APPLICATION NO.	FILING DATE	FIRST NAMED INVENTOR	ATTORNEY DOCKET NO.	CONFIRMATION NO.
09/617,749	07/17/2000	Jerry McKinney	Clearstrm-6	8682

BARRY, CHESTER T

<b>Office Action Summary</b>	Application No.	Applicant(s)	
	09/617,749	MCKINNEY, JERRY	
	Examiner	Art Unit	
	Chester T. Barry	1724

Fig. 1 (SIDE VIEW)

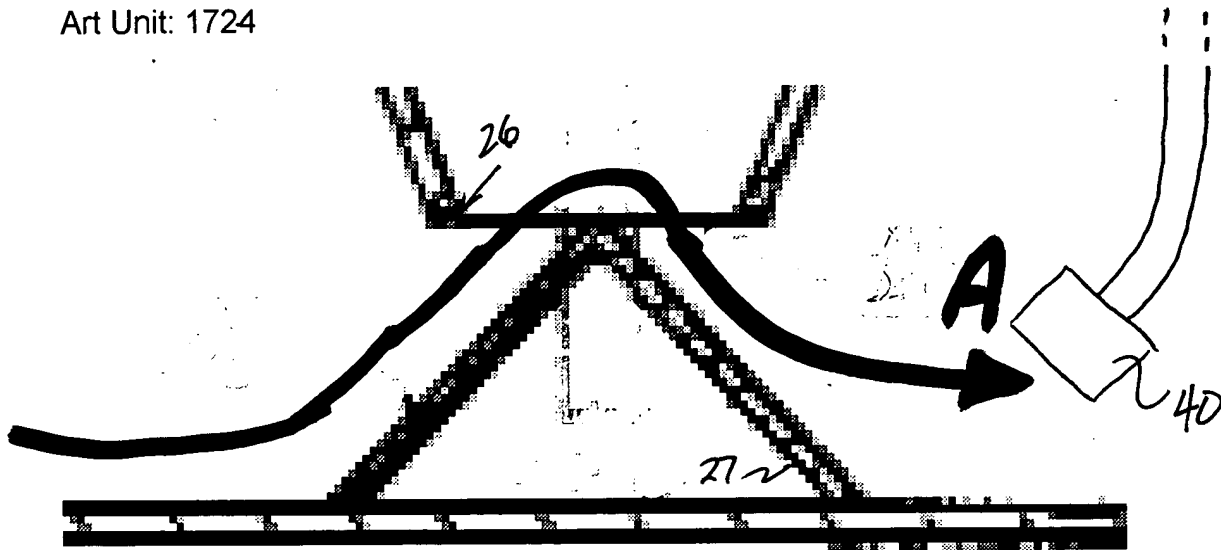
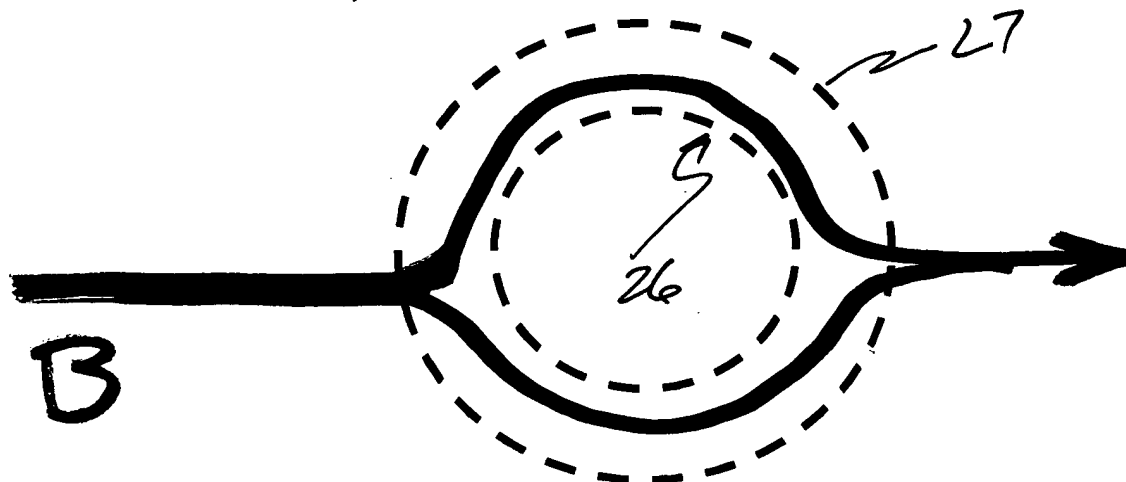
a vessel (10)<sup>11</sup> defining an aeration chamber (20) containing aerobic bacteria into which wastewater containing organic solids flows to be exposed to aerobic bacteria to aerobically digest the organic solids in the wastewater. The aeration chamber has a substantially flat bottom wall (A)<sup>12</sup> and a cylindrical side wall (10). McKinney '470 also describes an aeration system in the aeration chamber to support growth of the aerobic bacteria. McKinney '470 also describes a clarifier chamber formed in the vessel and into which wastewater from the aeration chamber flows upwardly toward an outlet pipe (30) through which the wastewater flows from the wastewater treatment plant. The clarifier chamber is defined by a partition in the form of an inverted, truncated cone (18) into the bottom of which (clarifier opening 26) the wastewater flows from the aeration chamber. The aeration system forms an aeration area adjacent the intersection of the bottom and side walls of the vessel. During periods in which one of the two diffuser is taken off line by closure of valve 42 or 44,<sup>13</sup> the aeration system provides sufficient recirculation liquid flow (by dint of sufficient aeration gas flow) such that all solids suspended within the plant are forced into circulation. Inherently, during shut-off of one of the two diffusers, a current pattern having at least one first component flowing upwardly in a direction perpendicular to the bottom wall of the vessel and parallel to the side wall of the vessel, second and third components that flow in opposite directions around the partition which defines the clarifier chamber, a fourth component that flows

<sup>12</sup> While McKinney '470 does not describe a substantially flat bottom wetted surface by virtue of the conic-shaped wetted surface of the deflector, a substantially flat bottom wall of the vessel is clearly shown. It is on this substantially flat bottom wall that the deflector is attached. See Fig. 3. *infra* ("A").

along the opposite side wall to the bottom, and sixth and seventh components that flow in opposite directions adjacent the bottom wall of the vessel is induced by the aeration gas flow. The aeration system provides sufficient oxygenation gas to allow the aerobic bacteria to digest the organic solids in the wastewater. It is unclear if the current pattern induced by the aeration gas flowing through only one of the two diffusers has a fifth component that flows across the bottom under the opening to the clarifier chamber. That is, it is unclear if a current component rises up over a portion of the deflector 27 underlying clarifier opening 26 and back down the opposite side of the deflector towards the solitary operational diffusers without being swept up into the clarifier proper given the hydraulic driving force present at times when wastewater is actually flowing<sup>14</sup> into the treatment plant through inlet 24. Furthermore, it is unclear during periods of no wastewater influx whether currents flowing across the bottom wall would rise up over at least a portion of the deflector underlying the clarifier opening, as shown by arrow "A" in Fig. 1 *infra*, or if the "cross-flow" would simply separate laterally into two branches "B" at the intersection of the deflector and the bottom wall, as shown by arrows "B" in Fig. 2 *infra* (without any split flow lying underneath clarifier opening 26).
